**SUBJECT: BILLS 136 (2025) AND 137 (2025), RELATING TO THE  
RENOVATION OF 60 SOUTH CHURCH STREET, WAILUKU,  
HAWAII (BFED-8)**

**PROJECT:** 60 S. Church St.  
**SUBJECT:** Waterproofing

**SUBJECT: MOISTURE REPORT – 60 S Church Street-Lower Roof**

Exhibit - 14

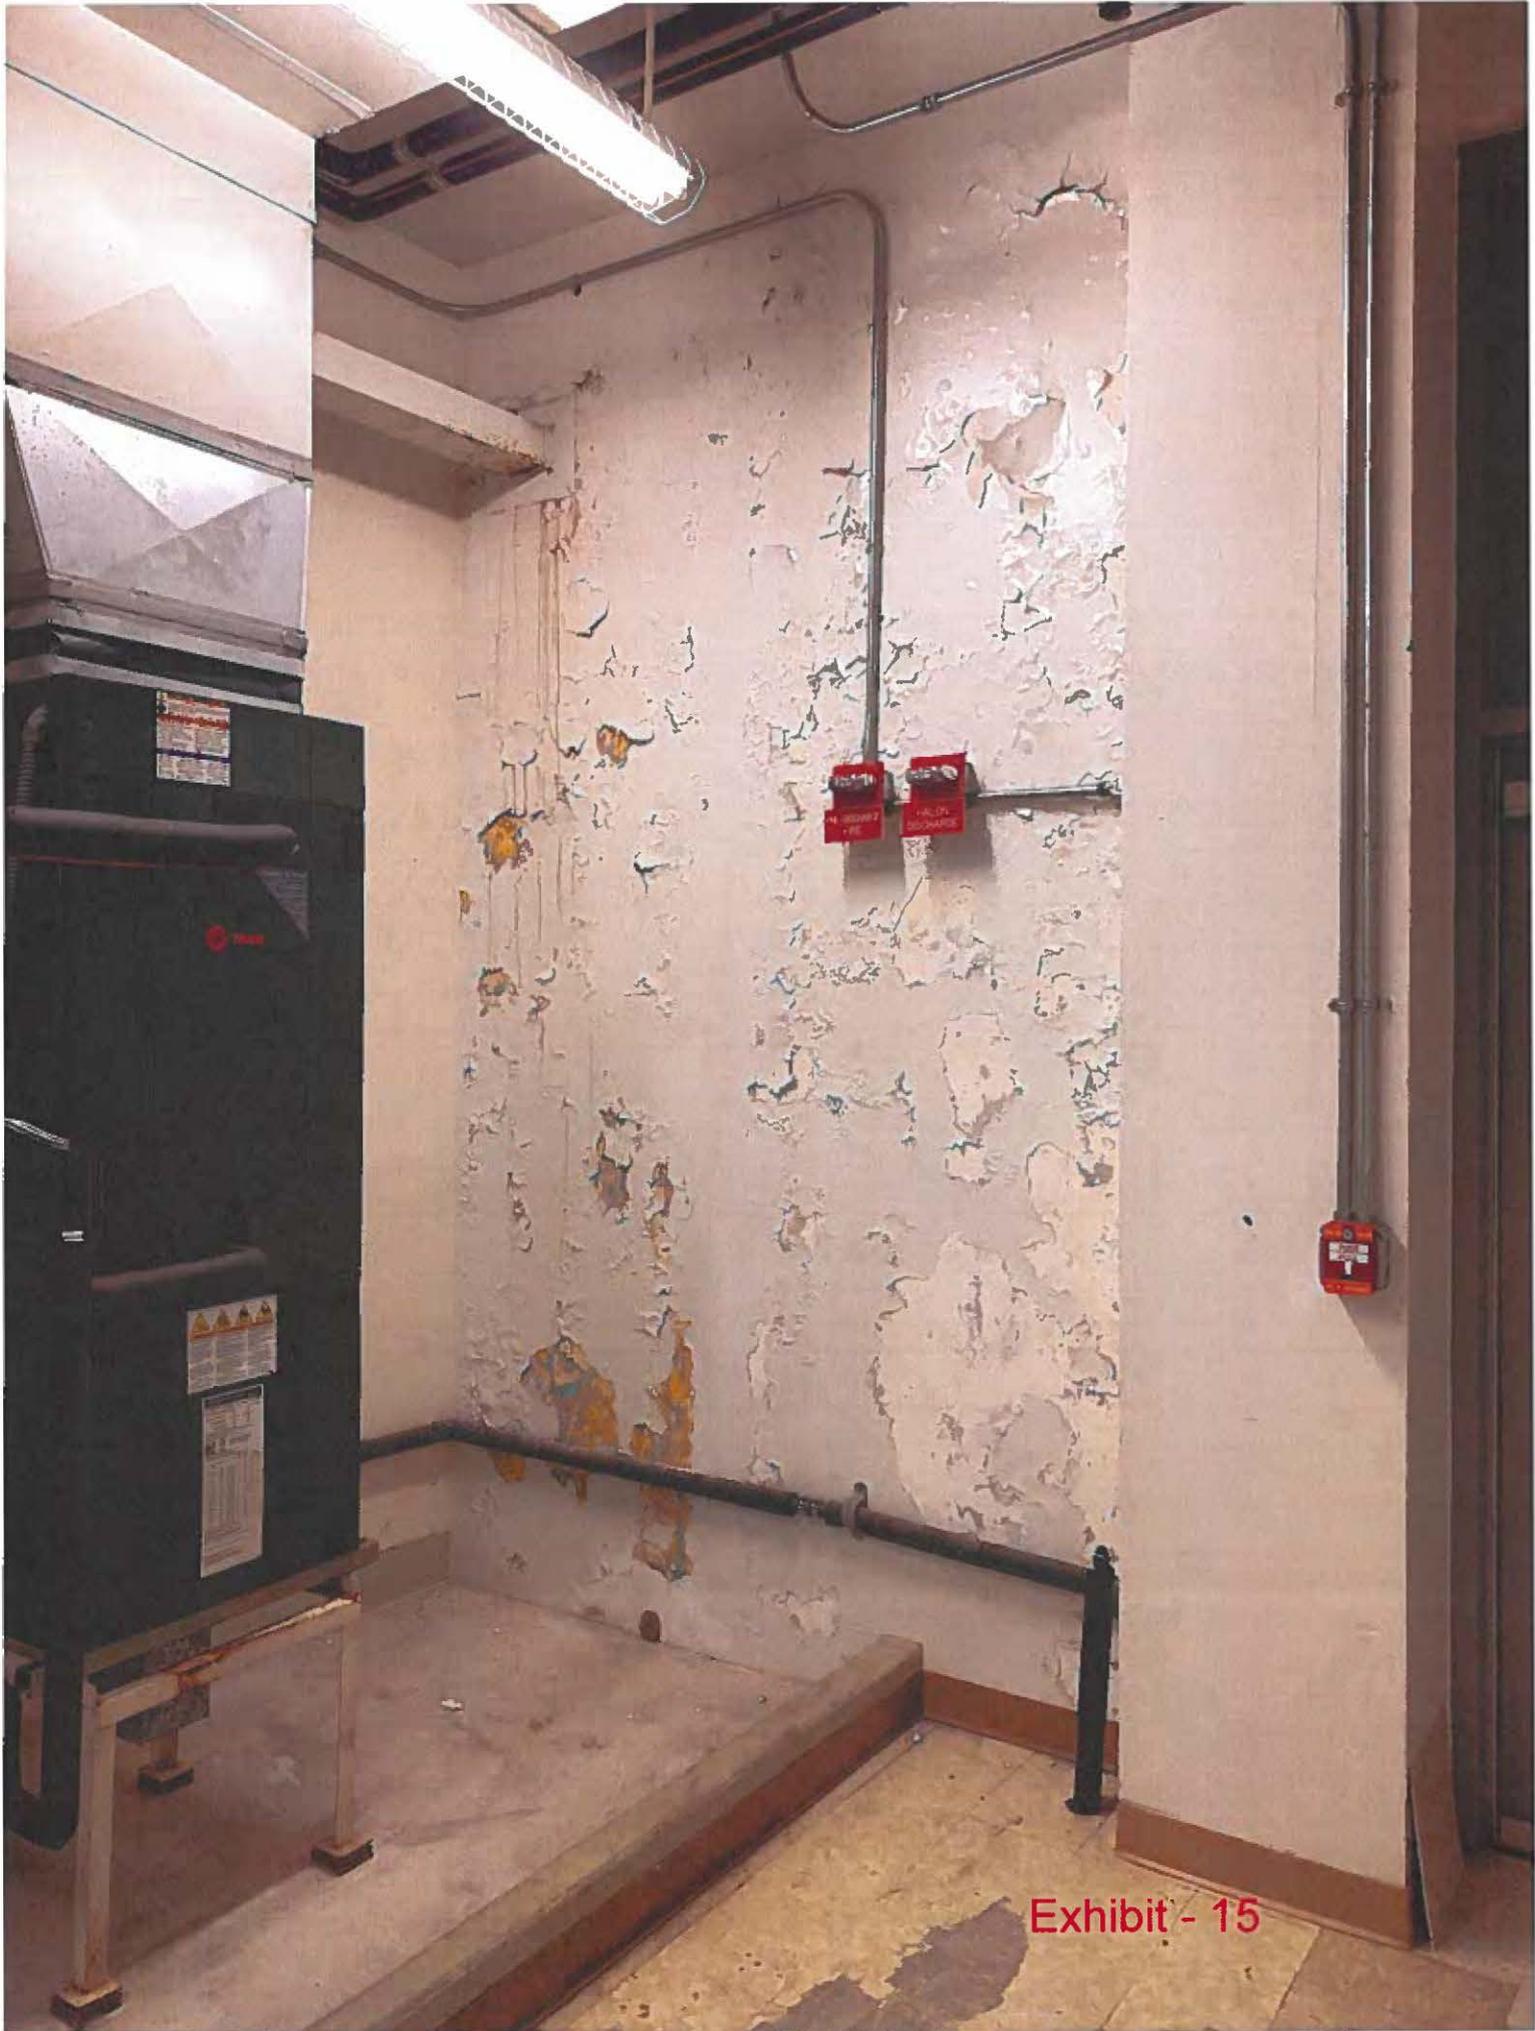
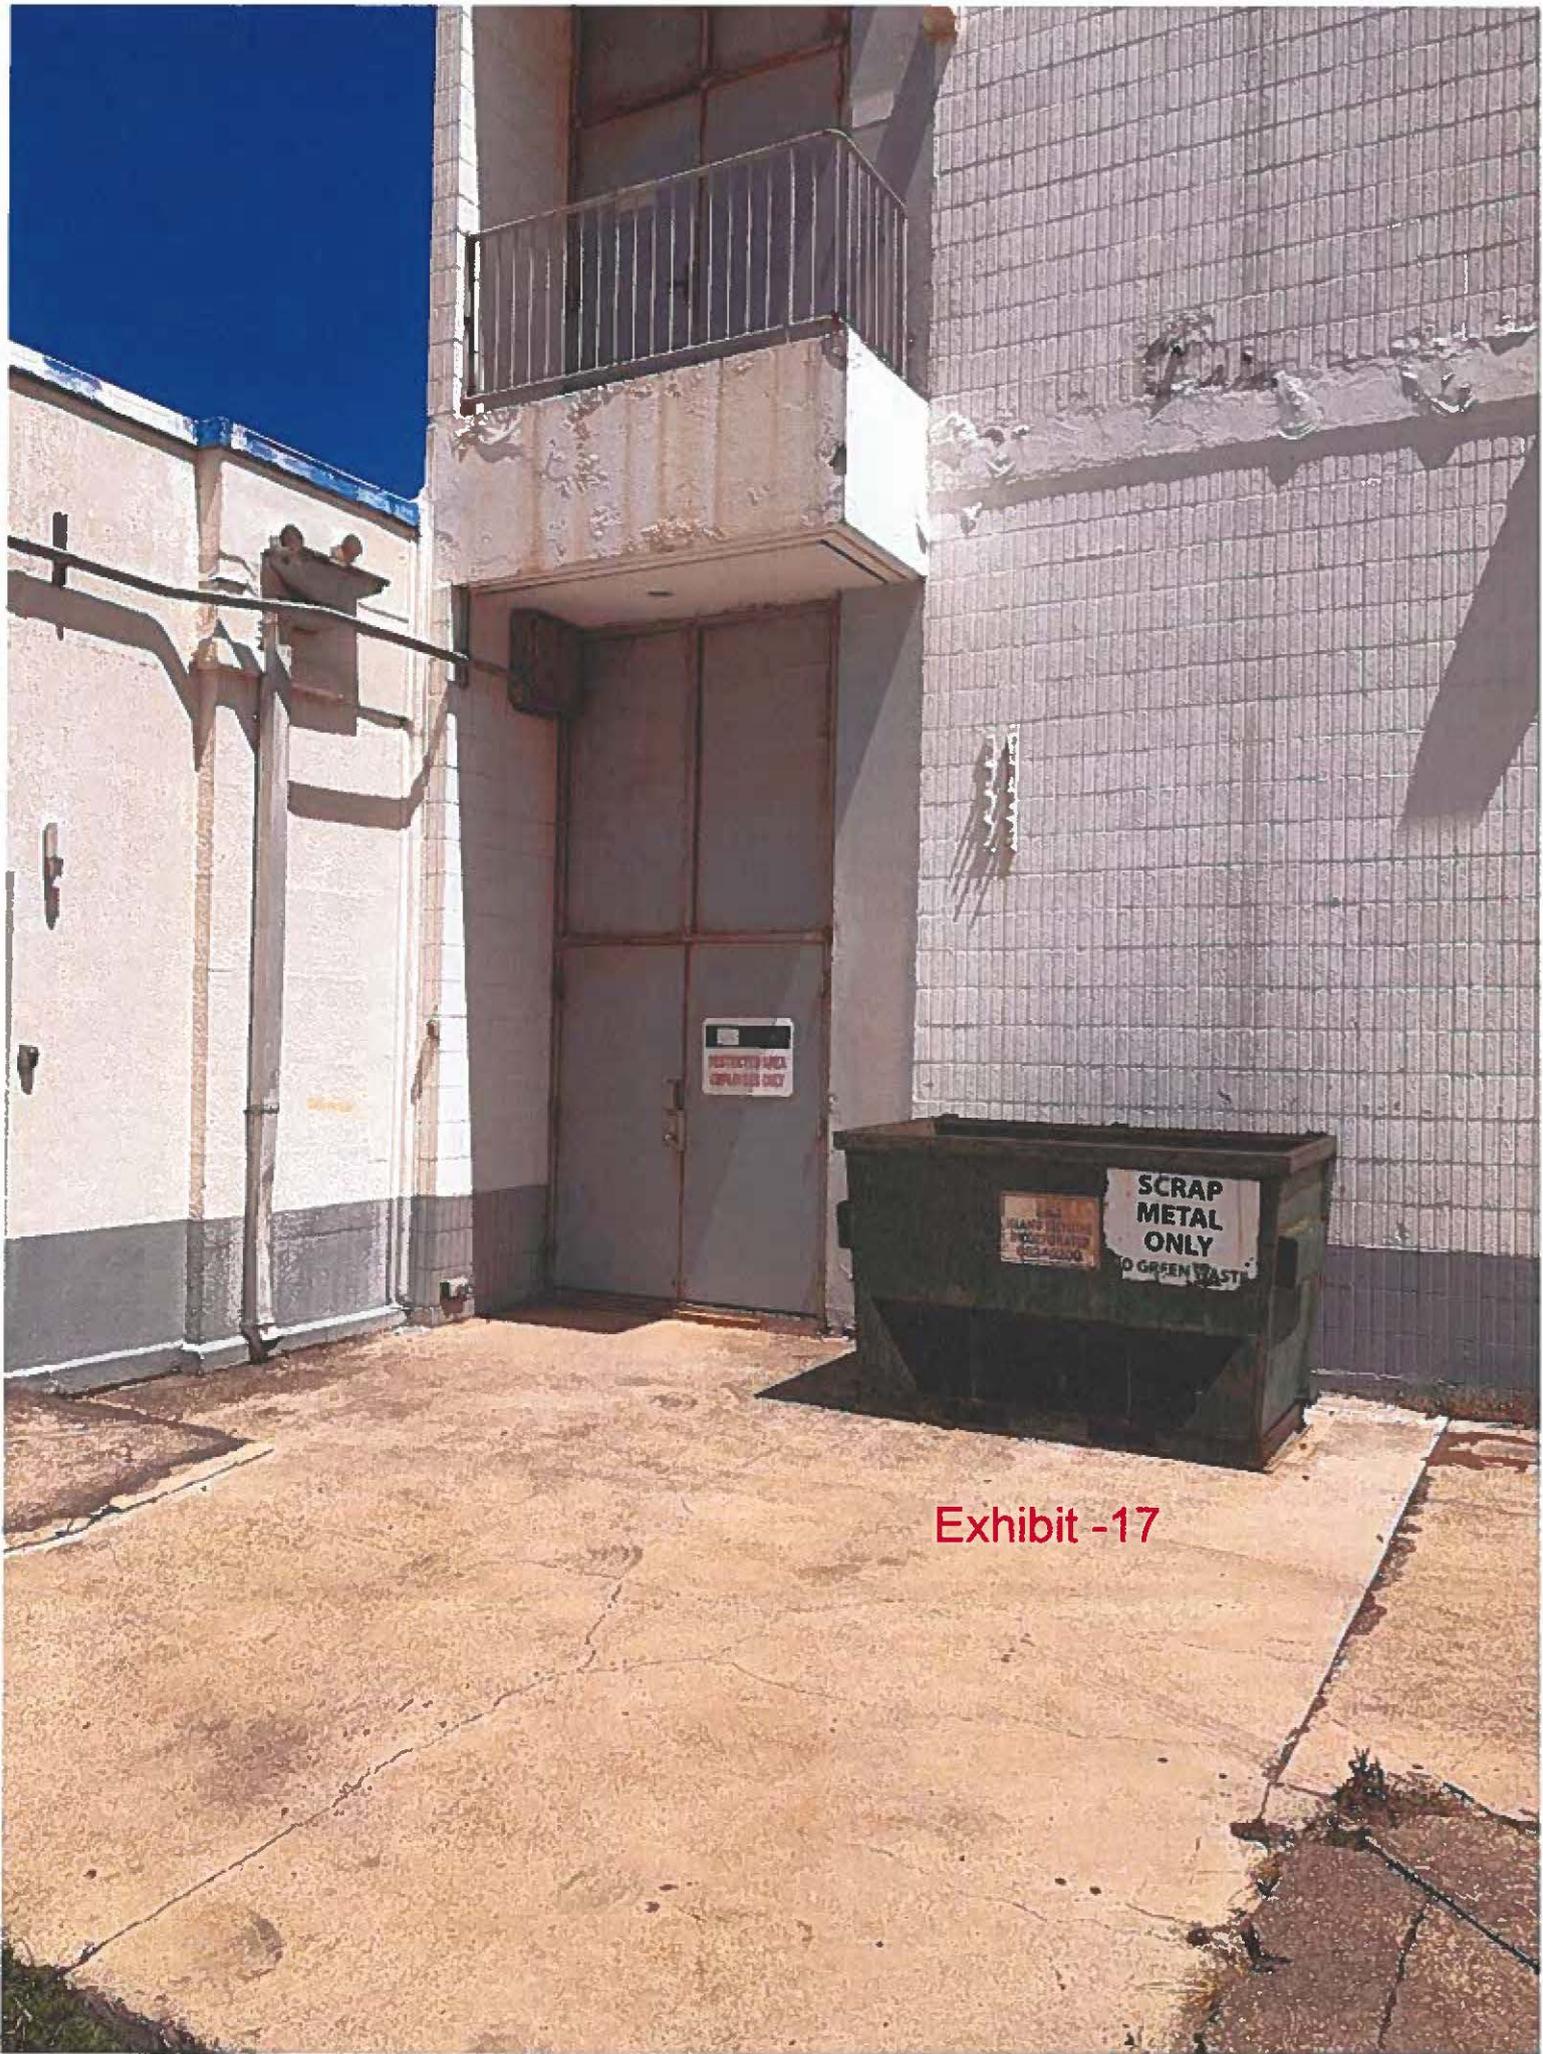
3.2.1.2 At the blistered portions of the interior walls, the skim coat plaster appears to be sound, not delaminated.  
The 1<sup>st</sup> coat, a thin film off a medium blue paint, is sound, well adhered, not blistered.  
The 2<sup>nd</sup> coat, a thin film of tan paint, appears to be sound, well adhered, not blistered.  
The final coat, a heavy film of an off-white paint is extensively blistered (see photos Exhibits 13, 14, 15 & 16).

DS Q: **What is the cause of blistering at this area?**  
ADL: The small area of blistering on the south wall, at the 3<sup>rd</sup> floor was caused by the same mechanism that caused blistering on the north wall- water getting into the CMU, probably at the CMU to concrete beam joint at the top of the 3<sup>rd</sup> floor.

3.2.2.1 Remove the paint where the surface is blistered and at least 12" beyond the blistered edge.

3.2.2.2 Feather the edge of the area where the paint has been removed.

3.2.2.3 Coat the wall with

3.2.2.3.1 A penetrating primer

3.2.2.3.2 An asbestos encapsulant paint such as SerpiFlex Asbestos Encapsulant Formula 2

Exhibit -17

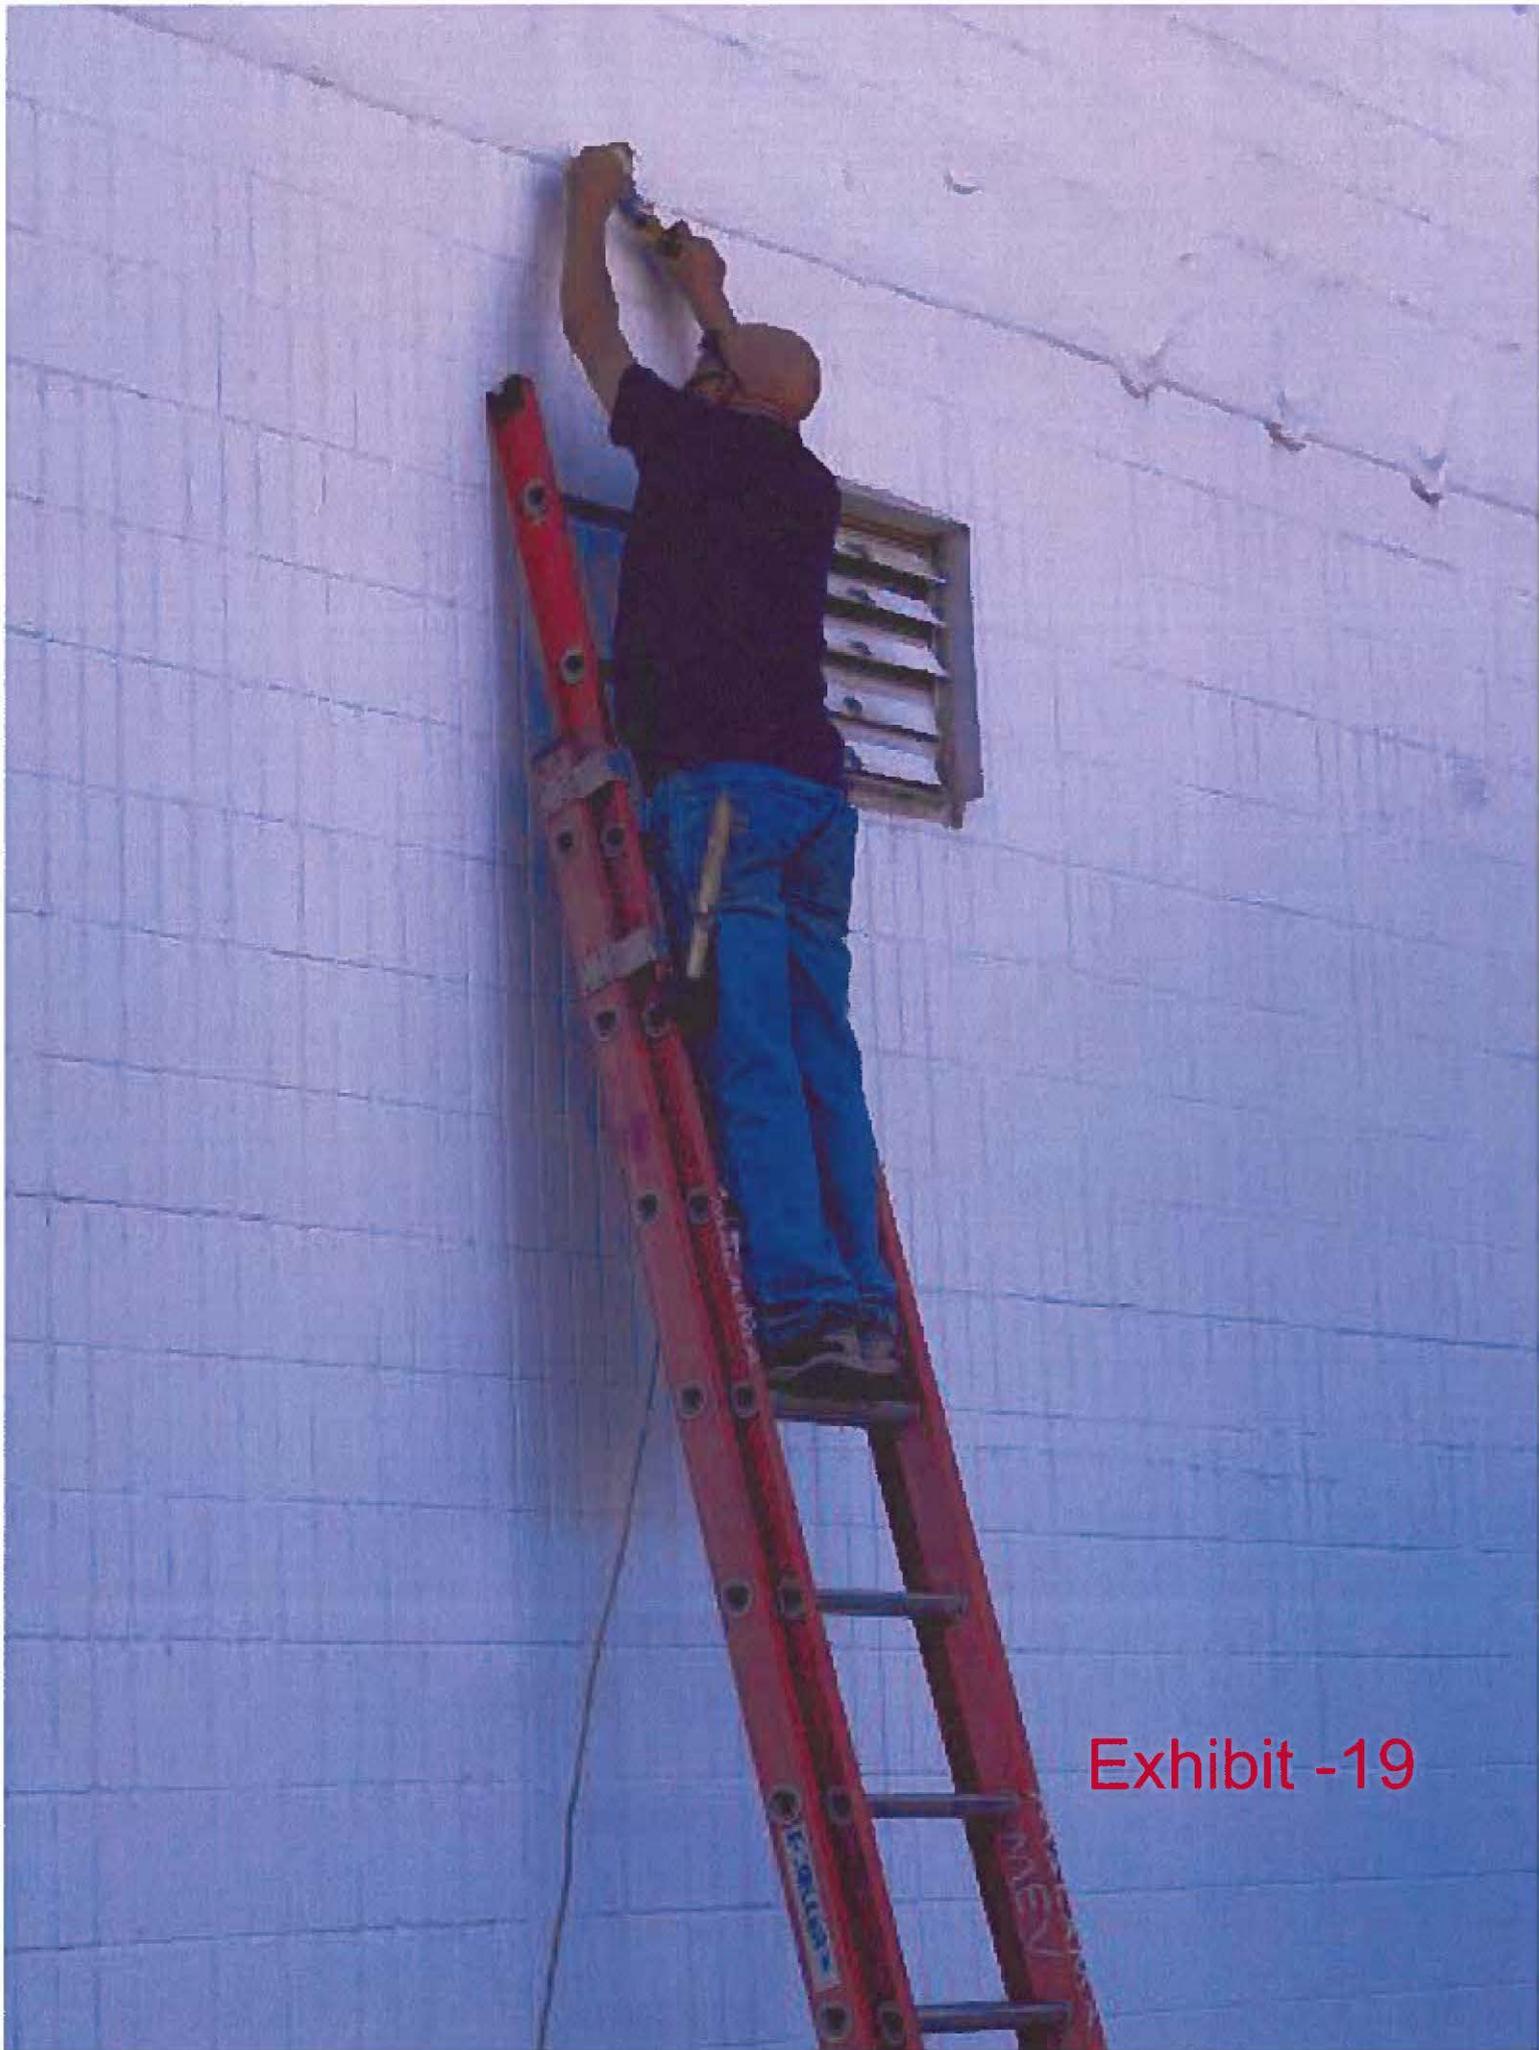
3.1.4 The north wall has small balconies (4' x 7') at each end of each floor. Two at the 2<sup>nd</sup> floor, 2 at the 3<sup>rd</sup> floor and 2 at the roof, for a total of 6, including a similar extension at the roof level. All have cracks & spalling (see photo Exhibits 17 & 18).

DS Q: **What about demolishing the balconies altogether?**  
ADL: It is my opinion that the cost to remove the balconies will be more, probably much more, than repairing the spalls and that repairing the balconies will preserve the visual integrity of the building.

3.1.7.3 The cracks and spalling on the balcony projections at each floor (including the roof) need to be repaired before repainting.
